PHASE I REVIEW: DOE STUDY PLAN FOR CHARACTERIZATION OF THE SITE
SATURATED-ZONE GROUNDWATER FLOW SYSTEM
(STUDY PLAN 8.3.1.2.3.1, Revision 0)

Neil Coleman

Hydrologic Transport Section
Hydrology & Systems Performance Branch
Division of High-Level Waste Management, NMSS
U.S. Nuclear Regulatory Commission

July 22, 1991

Figure 5.1-1. Summary network for Solitario Canyon and potentiometric-level activities show drilling schedule.

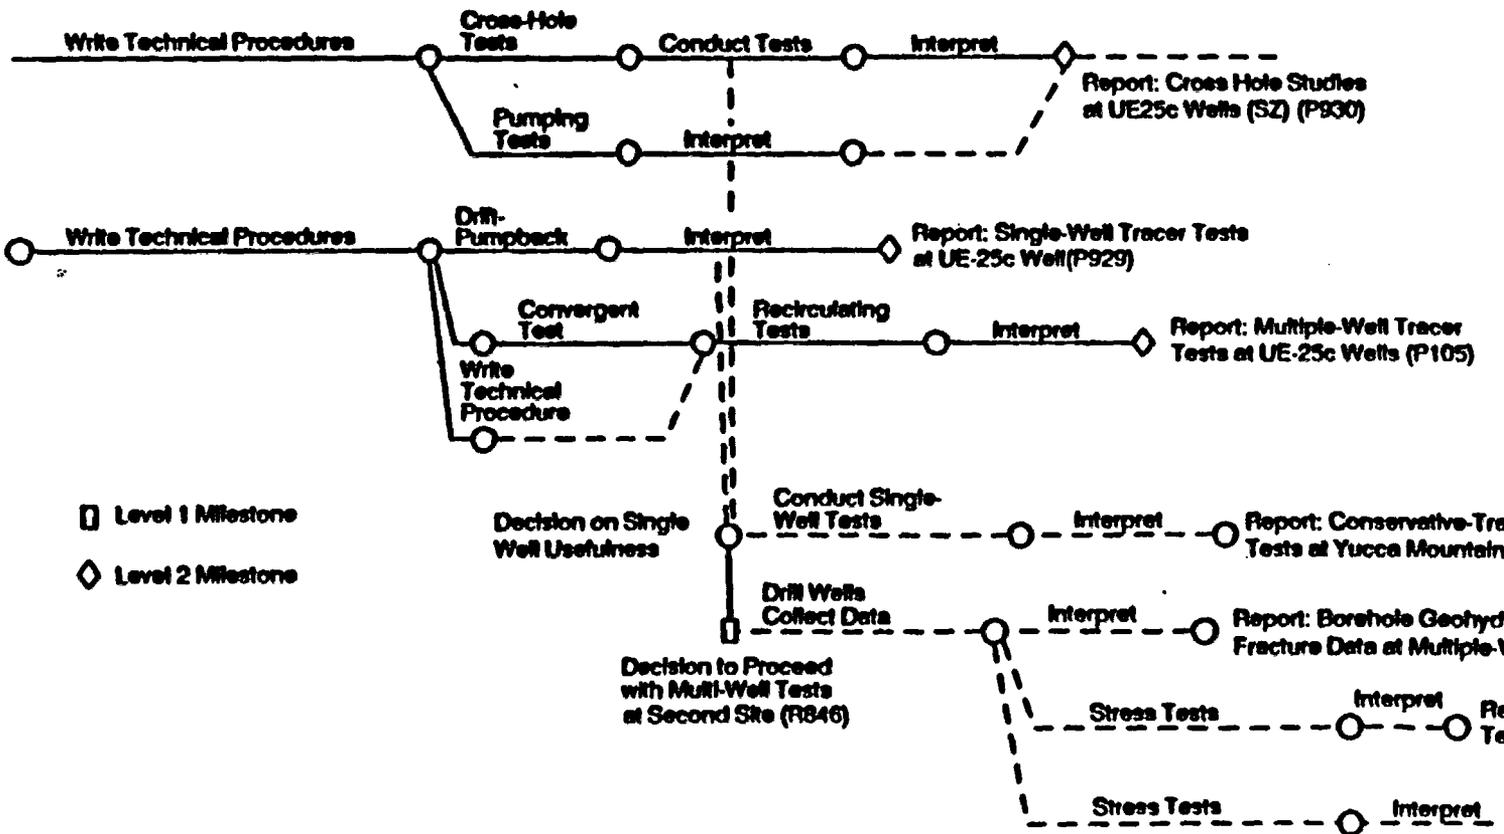
An approximate timeline is shown starting on page 5.1-2 of the study plan. The DOE plans to develop durations, and start and finish dates for the activities. The related LANL study plan on reactive tracer testing also contains a general timeline, and states that the start of LANL's field experiments depends on when the USGS conducts its hydraulic and conservative tracer tests. LANL predicts that its field experiments will take 12-20 weeks.

It is stated in Section 5.1 that "Specific durations, and start and finish dates for the activities are being developed as part of ongoing planning efforts". As for time interrelationships among principal activities associated with this study, it is also noted in Section 5.1 that "the testing of the saturated zone flow-system as described in this study plan will be dependent on the drilling schedules of the water-table holes". Relative time interrelationships are provided in Figures 5.1-1 and 5.1-2.

The DOE should prepare a timeline that shows all proposed work activities under the site saturated zone investigations and any other work planned in the vicinity of the C-hole site. This timeline should include durations and start and finishing dates for all activities. If it is not yet possible to include actual start dates, then a detailed timeline should be prepared that clearly shows the relative starting times and durations for all related tests, including the LANL program of testing.

Figure 5.1-2. Summary network for hydraulic and conservative tracer tests.

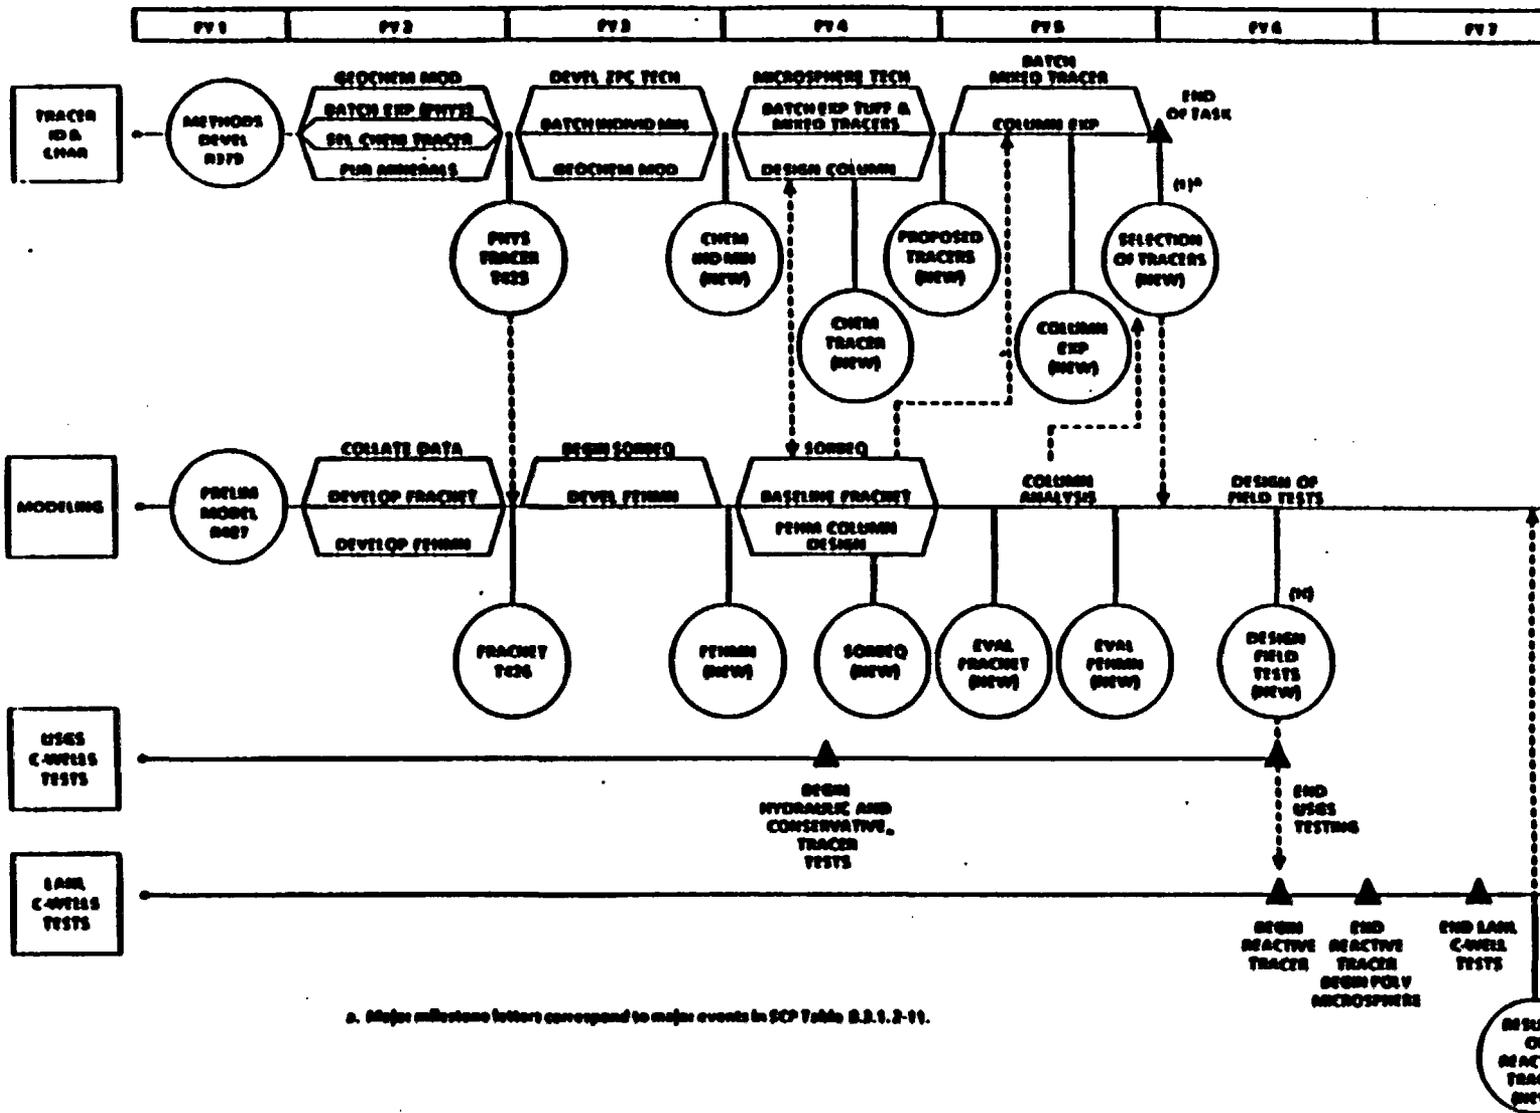
- The schedules for the USGS and LANL study plan work are attached. The USGS schedule shows that many tests are planned for the third and fourth fiscal years. These include cross-hole, pumping, drift-pumpback, and convergent tests. The LANL schedule suggests that the reactive tracer testing (and other LANL field tests) will begin when the USGS testing ends, toward the middle of the sixth fiscal year. Under the USGS schedule, the field testing at the C-hole site would end in the fifth fiscal year. Although the schedules show a planned separation in schedules between the USGS and LANL field tests, there is considerable need for mutual planning and coordination. For example, the USGS report on interpretation of multiple-well tracer tests at the C-hole site is scheduled for completion at the same time that the LANL field tests would begin. However, preliminary USGS interpretations will undoubtedly be needed earlier to finalize plans for the LANL work. Finally, given the general sequencing of studies, any delays in the USGS program will result in corresponding delays in the later LANL work.
